DA2019/1139

Application No. DA2019/1139

Address: Lot 1 DP 204401 – 19 Manly Road SEAFORTH

ATTENTION – DEVELOPMENT DETERMINATION PANEL

Figure 10 - Shadow effect

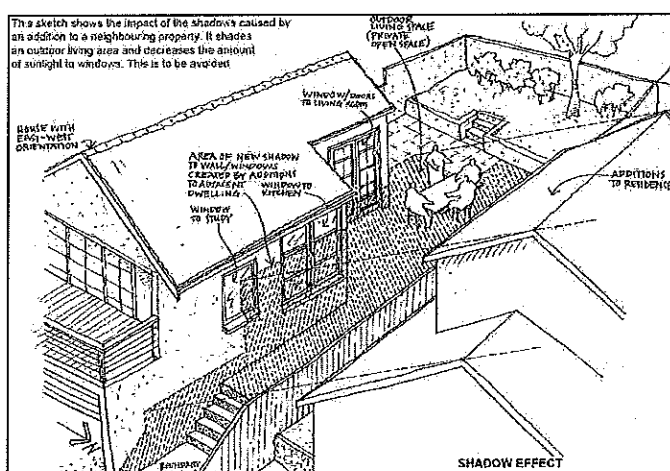
I will illustrate this with the following example and make reference to clause 3.4.1.2 a) and Figure 10 from the Manly Development Control Plan 2013.

For adjacent buildings with an east-west orientation, the level of solar access presently enjoyed must be maintained to windows or glazed doors to living rooms for a period of at least 2 hours from 9am to 3pm on the winter solstice (21 June).

I will compare this with 2 photos I have taken from our living room. As you can see, with the current proposal we will no longer receive any solar access from our living room. To compound our concerns, our solar panels will also be impacted. We have received independent solar expert advice who believe this development will make the use of solar energy ineffective from the overshadowing which will lead to increased electricity costs.
